**Contract No. EP/SP/66/12**  
**Integrated Waste Management Facilities, Phase 1**  
**Proposal for Relocating Impact Water Monitoring Locations C1, C2 and S2 (Rev. C)**

# PROPOSAL FOR RELOCATING IMPACT WATER MONITORING LOCATIONS C1, C2 and S2

**SUMMARY OF RESPONSE TO COMMENTS**

Proposal for Relocating Impact Water Monitoring Locations C1, C2 and S2 (Rev B)

Figure 1.1 - Existing monitoring locations and fairway

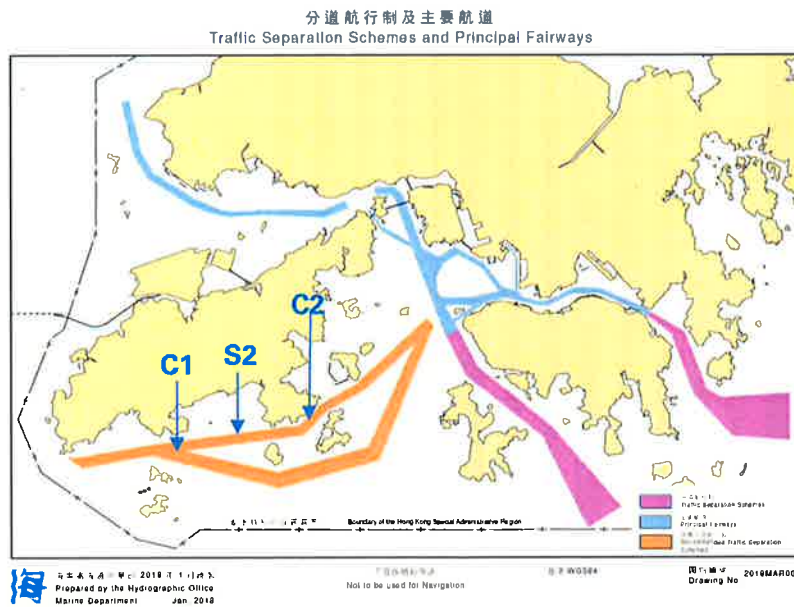
Section 1.1 is suggested to be amended  
 "1.1 As existing monitoring ... passing through. ~~Since Marine Management Liaison Group (MMLG) Meeting No.7 dated 13 September 2018 raised out Marine Department and other stakeholders had raised out safety concern on marine traffic issues regarding shuttle boats travelling near Adamasta Channel where having frequent High Speed Ferry transit along in the Marine Management Liaison Group (MMLG) Meeting held in September 2018. (Attachment no.3 – MMLG minute no.7 item 3.3). In addition, there are marine constraints for this project. The vessel of ... Speed Ferry transits (See Attachment no.3 Presentation Slides no.9 & 34 for the MMLG meeting).~~"

Noted and revised.
